Our Ref: 36519-001-02
Your Ref: MCUC 2025_5867/1

**Information Request Response – Development Application MCUC 2025_5867/1
Material Change of Use for Short Term Accommodation (intensification of existing
backpackers accommodation)
37-39 Warner Street Port Douglas – Lot 50 on RP896319**

Port Douglas Backpackers, MCU for Short-term Accommodation Intensification – Traffic Impact Assessment

1 3D - STREET VIEW
 @ A3

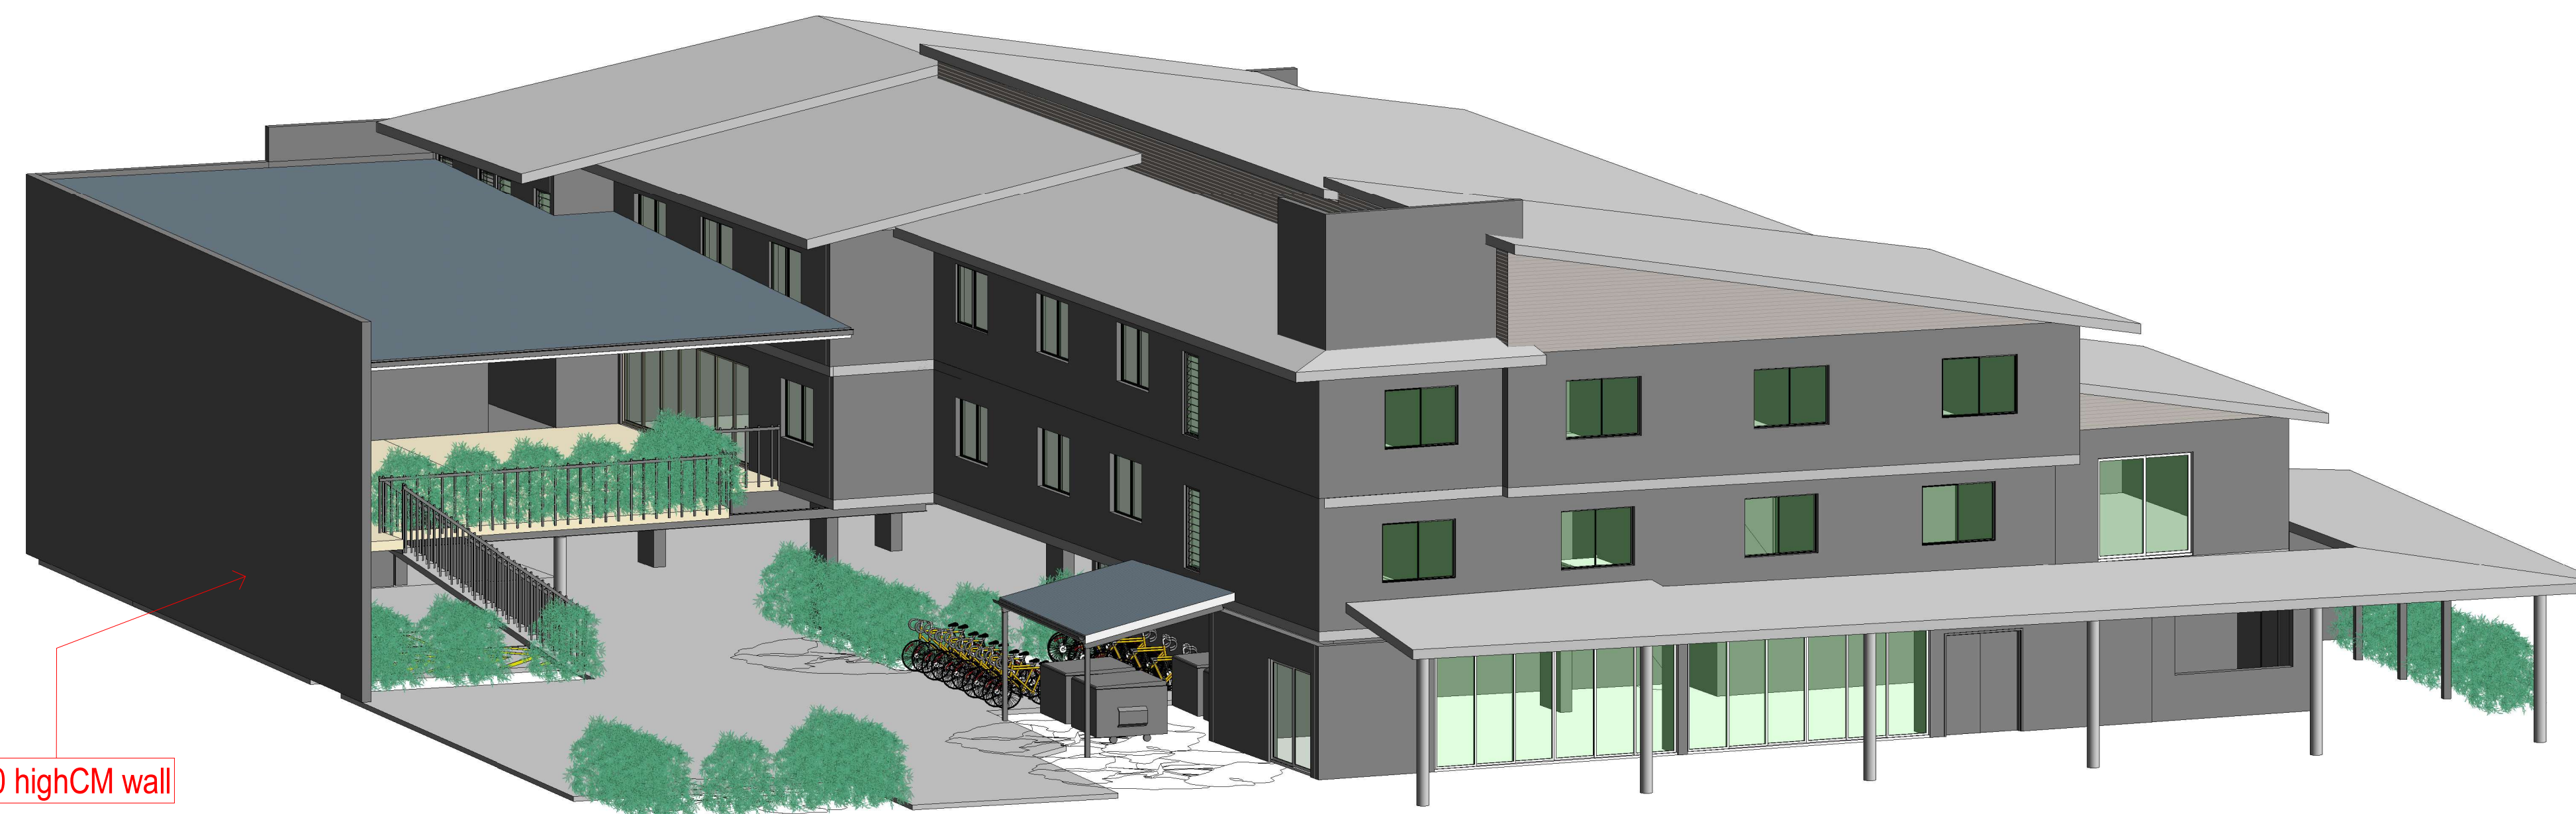
8. *Provide details of the height of the wall to be constructed on the south eastern boundary.*

Please refer to a copy of the amended Proposal Plans prepared by 8 Pencils included within **Attachment B**. The proposed new wall is 7.8m high and maintains privacy to users of the site and adjoining uses.

7800 highCM wall

DRAWING
 CARPARK / REFUSE PLAN

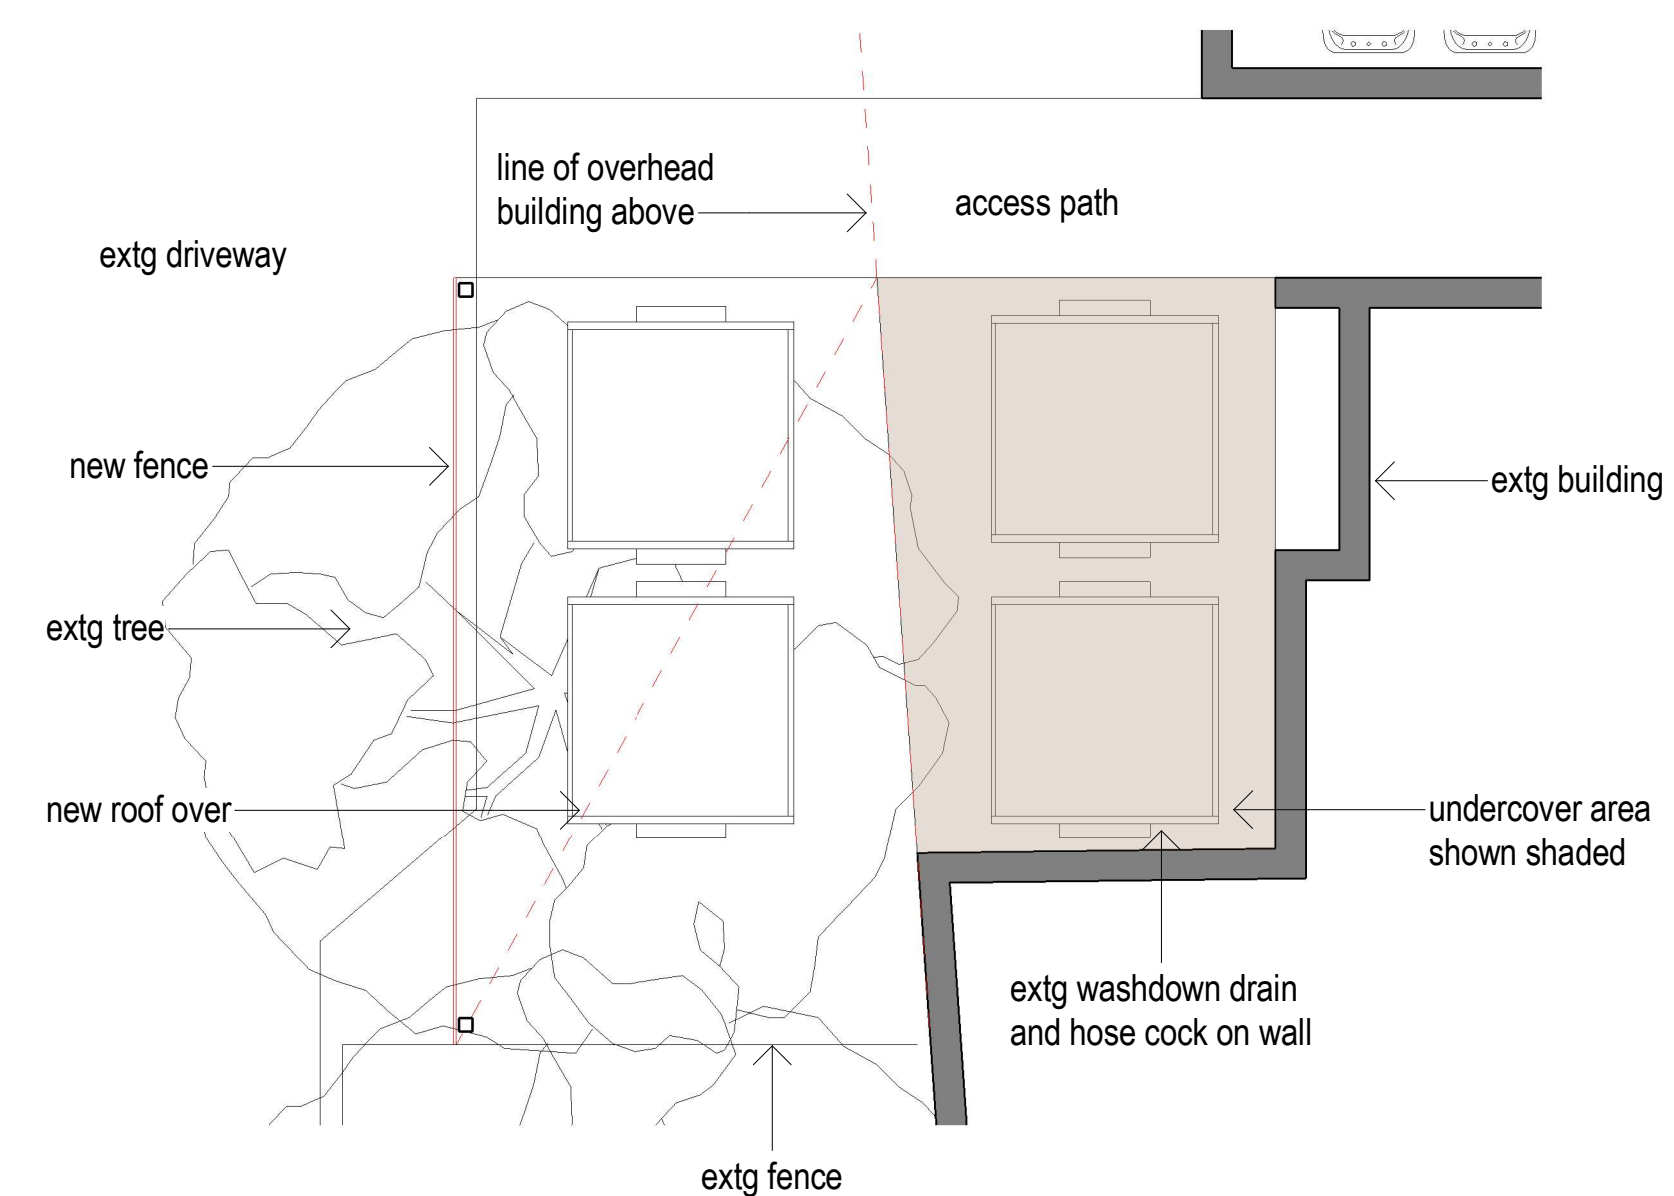
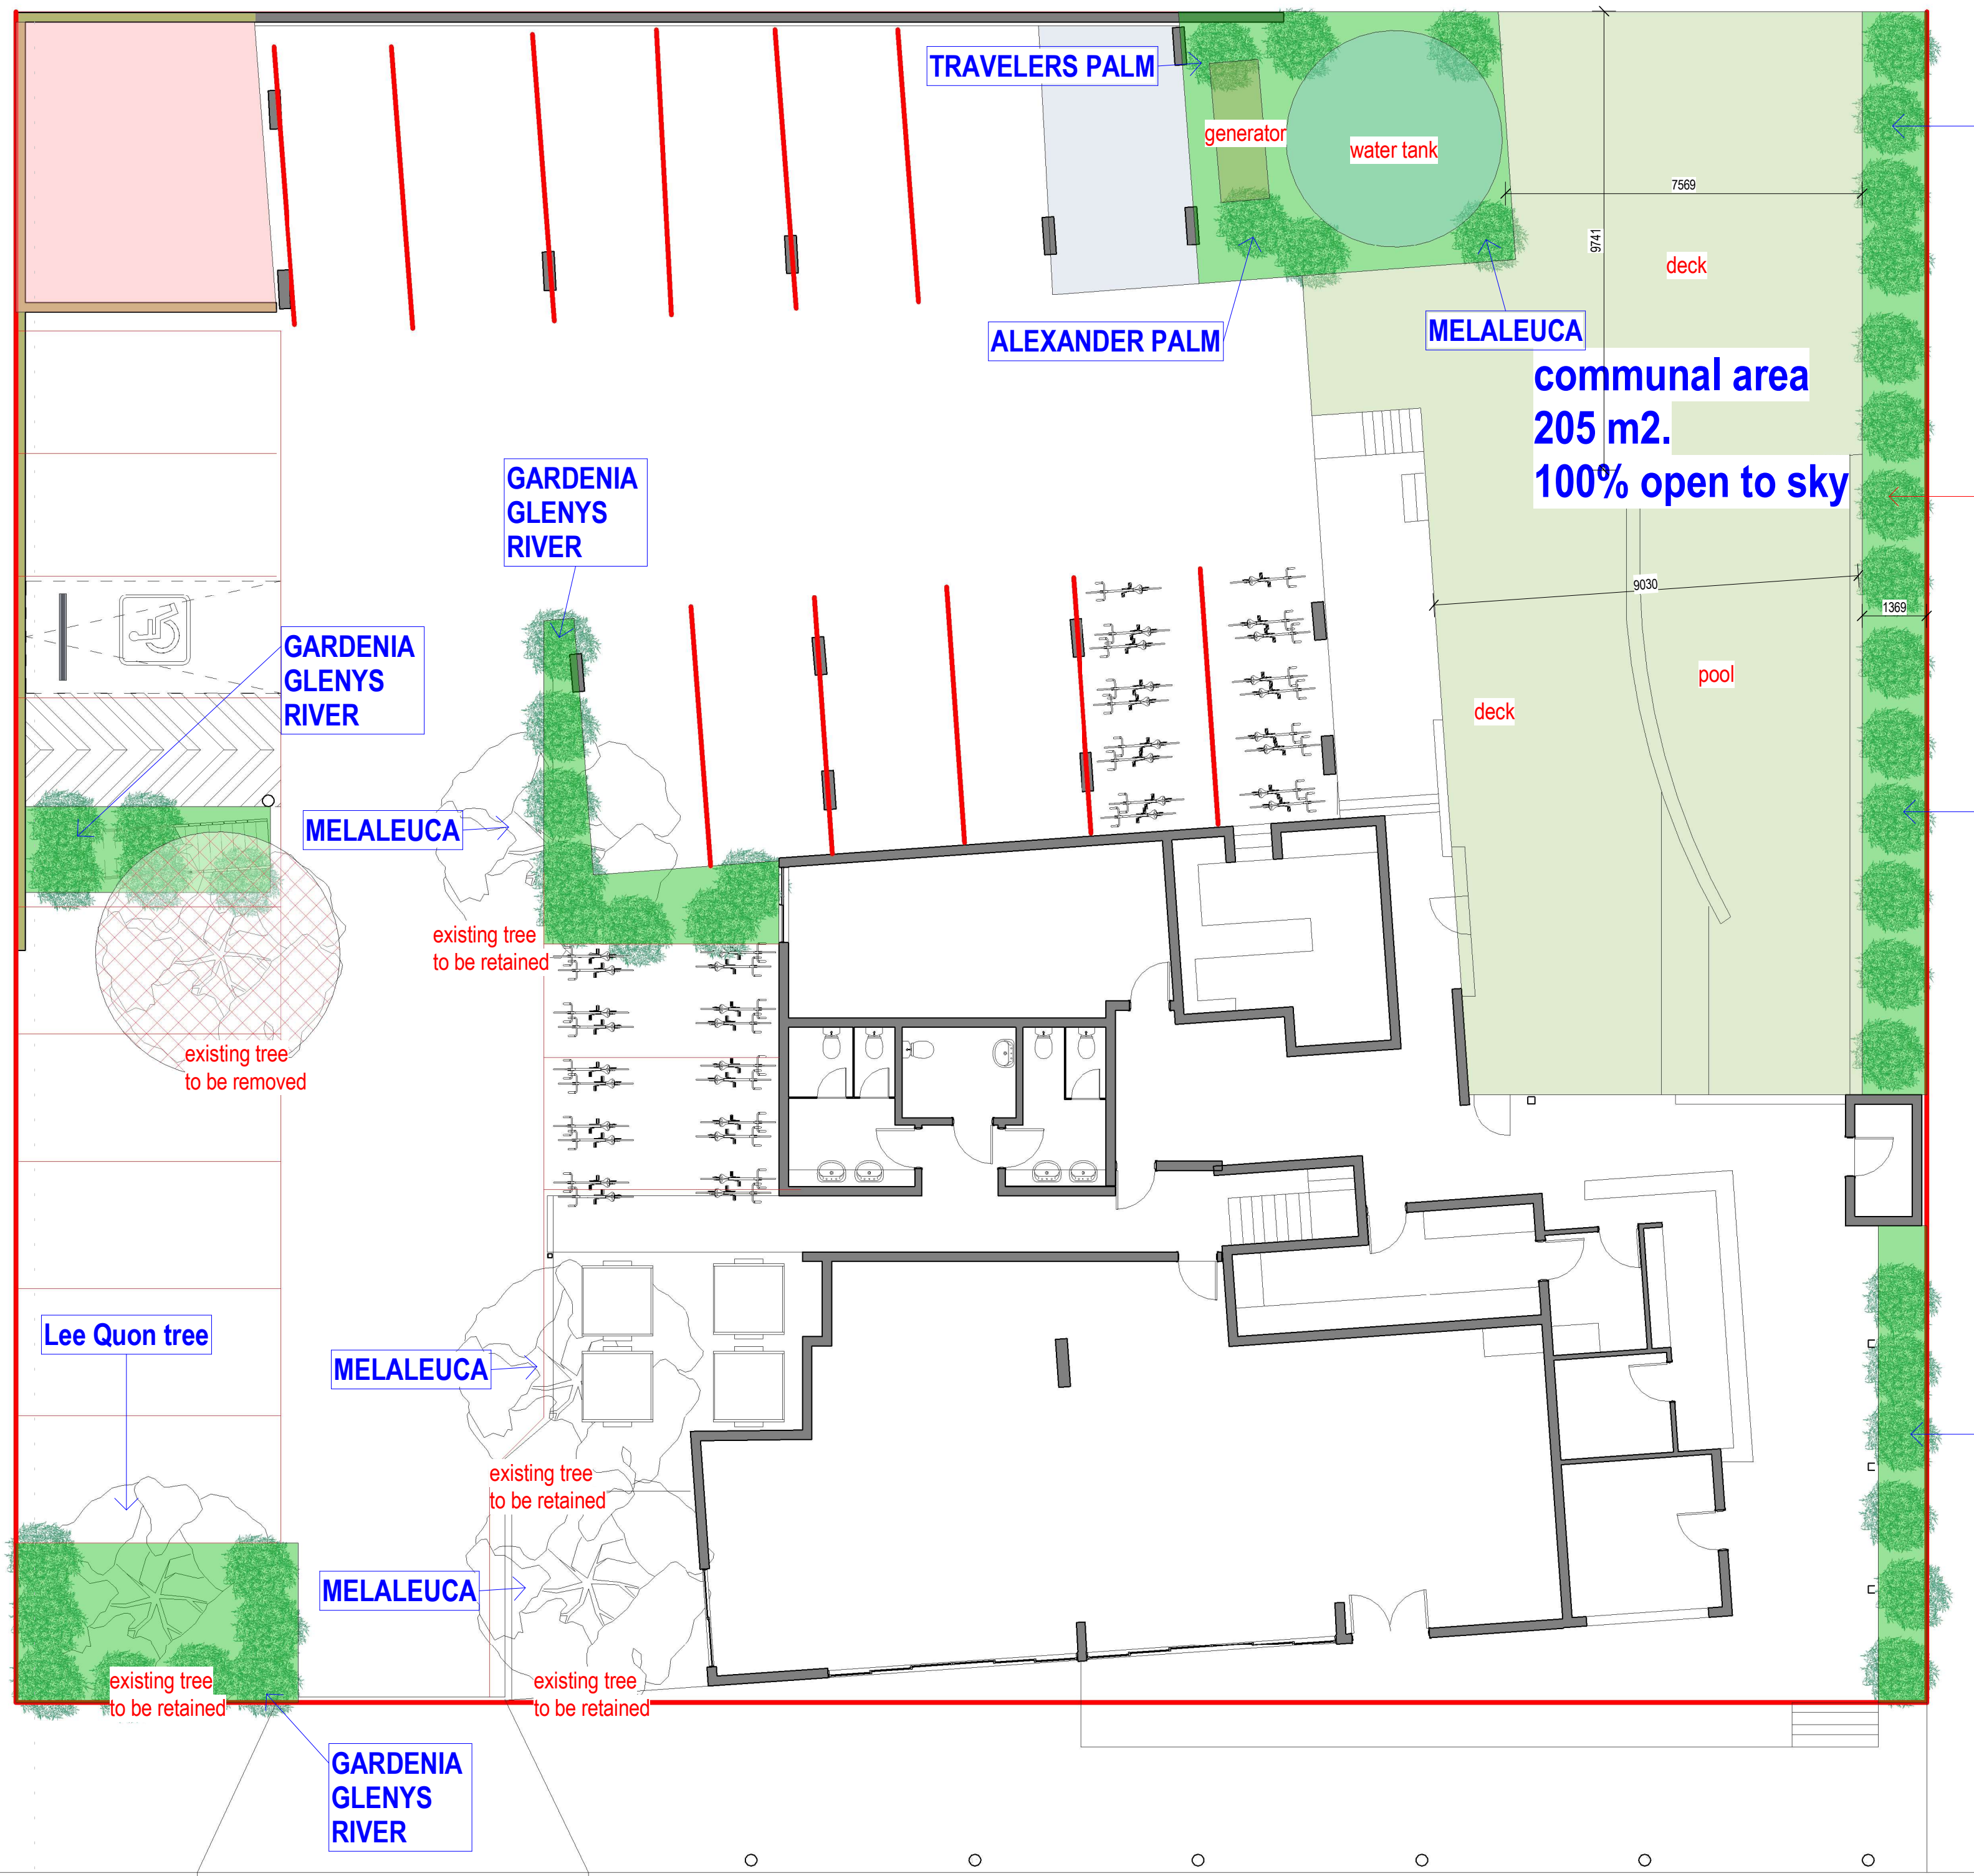
Provide a detailed plan showing an onsite waste and recyclable storage area that;

- *Is roofed, bunded and connected to sewer with an approved collection device at the drainage point to sewer;*
- *Has an impervious surface for the storage of waste containers with a suitable hose-cock with hose attached;*
- *Provides appropriate access and manoeuvrability for waste collections services and access for residents;*
- *Is located and designed so to avoid adverse amenity impacts within the site and to adjoining properties and street view; and*
- *Can provide for the number of bins required for the site; and*
- *Can be adequately accessed for collection.*

Please refer to a copy of the refuse plan included at Drawing A06 of the amended Proposal Plans prepared by 8 Pencils included within **Attachment B**. The plan demonstrates that the site can accommodate the required bulk refuse bins to service the development. Screen fencing will be provided to conceal the area from public view. The refuse store area is partially covered by the existing building overhead and existing trees will be retained in this area. The existing washdown drain and hose cock on the wall be retained.
